COMMENTS RECEIVED ON THE NOP AND INITIAL STUDY

Re: Notice of Preparation of Draft Environmental Impact Report and Initial Study for adoption of District Regulation 12: Miscellaneous Standards of Performance, Rule 12: Flares at Petroleum Refineries and Amendment of Regulation 8: Organic Compounds, Rule 2: Miscellaneous Operations; preliminary comments of Communities for a Better Environment (CBE)

Comments of CBE on scope of flare control rule EIR

To: Adrienne Bloch, CBE Staff Attorney, AJ Napolis, N. Cal. Director,
Greg Karras, Senior Scientist
From: Julia May, Environmental Consultant
Re: **Review of BAAQMD Reassessment of Flare Emissions
for Historical Study Period (6/1/01 – 8/31/02)**

Sulfur dioxide in air at 7th Street, Richmond during flaring by Chevron on April 21, 2004.^a

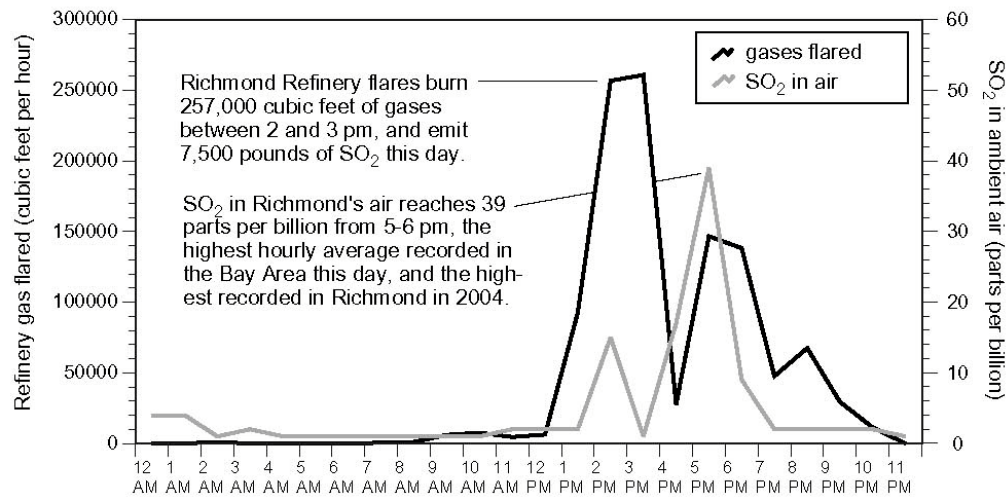
Direct measurements of ambient air quality should be evaluated before, during and after repeated flaring events that cause locally concentrated emissions. Measurements outside the Bay Area show that refinery emissions of benzene, toluene, xylenes and other pollutants contribute significantly to localized air pollution.²⁴ Measurements of Bay Area air quality are available at the fence line, neighborhood and regional scales. For example, SO₂ reached the highest hourly average concentration recorded in Richmond all year and the highest concentration recorded in the Bay Area that day during flaring by the Richmond Refinery that emitted about 3.4 tons of sulfur compounds (as SO₂) on April 21, 2004. See the chart below.

The draft EIR should evaluate ambient monitoring before, during and after all flaring that results in a high local concentration of emissions/square mile, for all pollutants emitted by flares, at all locations in the monitoring network, including fence line, local and regional (comparison) stations. This analysis should use the finest time scale (e.g., minute-by-minute if possible²⁵) that can be evaluated with existing data.
